Interactive comment on “A coupled Bayesian and fault tree methodology to assess future groundwater conditions in light of climate change” by J. J. Huang et al.

Received and published: 26 October 2014

Fig. 1.

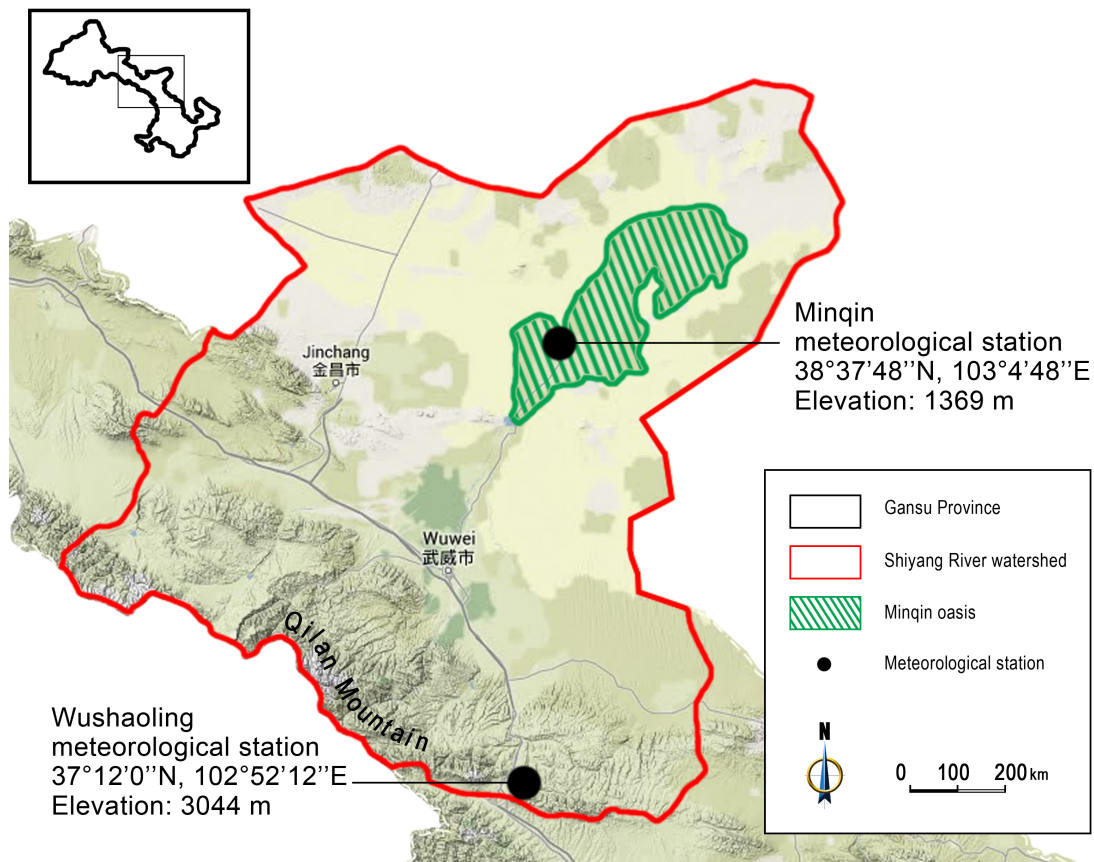
Figure 1 – It should focus on the area of the case study

A: Figure 1 have been revised as suggested
